McLaren 720S – Clutch Cooler Hose Clash Rework

Bulletin type: Service Campaign Bulletin
Reference number: SCB 14 L 003
Attention: Retailer Service Managers and Retailer Technicians
Affected vehicles: 720S Coupe and Spider
Situation: Potential for insufficient gap tolerance between components
Procedure: To action affected vehicles during next Retailer visit. Please refer to the information outlined in this document to ensure sufficient gap tolerance is created
Date: 16th January 2020

Layout overview - Clutch Cooler Hose with clip assembly (12) installed
(extract from SCB 14 L 003 WI)

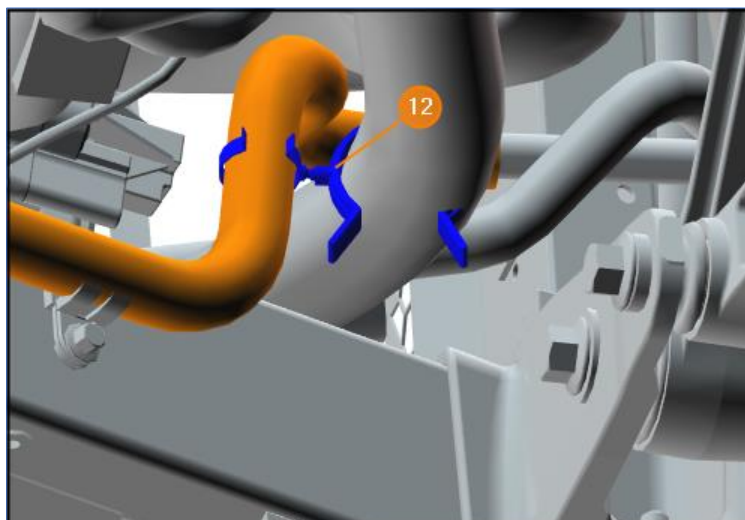
Through continuous product quality monitoring, it has been identified that a number of McLaren 720S vehicles (Coupe and Spider versions) may have an insufficient gap tolerance between the Clutch Cooler Hose and the Turbocharger Wastegate. This could cause damage to the components; therefore, a preventive rework solution has been released.

- Check the part number of the installed Clutch Cooler Hose and replace if necessary (if a P13 part is installed, replace hose)
- Install a double 'C' clip which will increase the gap tolerance

CARE POINT: If the required gap tolerance still cannot be met, replace the Clutch Cooler Hose. Do not adjust the hose position at the front hose clamp end as the required tension will not be met.
